SERVICE BULLETIN

M-1075

Safety Recall Code 093

P&A Custom Horn Cover Part No. 69528-98

Figure 1.

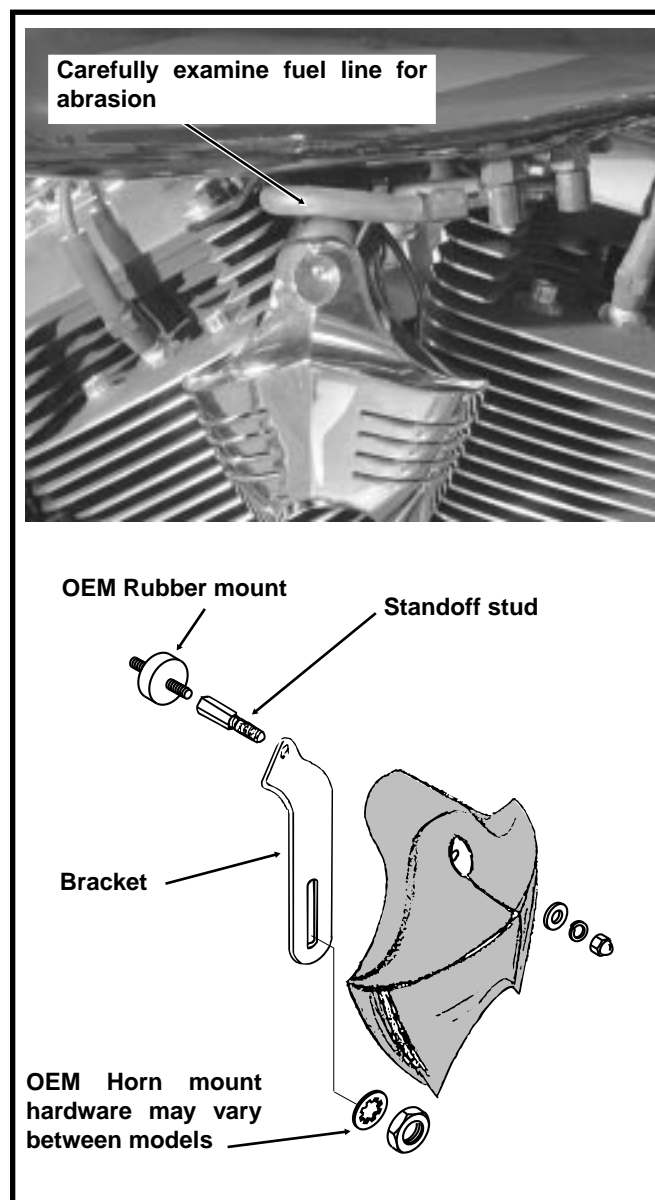
Harley-Davidson has determined that abrasion, leading to possible fuel leakage, can occur between the fuel line and the accessory custom horn cover, Part Number 69528-98. Fuel leakage could lead to personal injury.

1. Remove acorn nut and custom horn cover.
2. Remove mounting bracket and standoff stud from OEM Rubber mount.
3. Examine fuel line for abrasion. If fuel line shows evidence of abrasion/contact it MUST BE REPLACED. Consult appropriate Service Manual.

Figure 1 shows the horn installation on an EFI equipped motorcycle. Since this is a Multi-fit kit, the installation will vary on different models. ALL FUEL LINES, REGARDLESS OF MODEL, MUST BE CAREFULLY EXAMINED FOR CHAFING AND/OR ABRASION.

4. Install OEM horn and bracket assembly. Consult appropriate Service Manual.
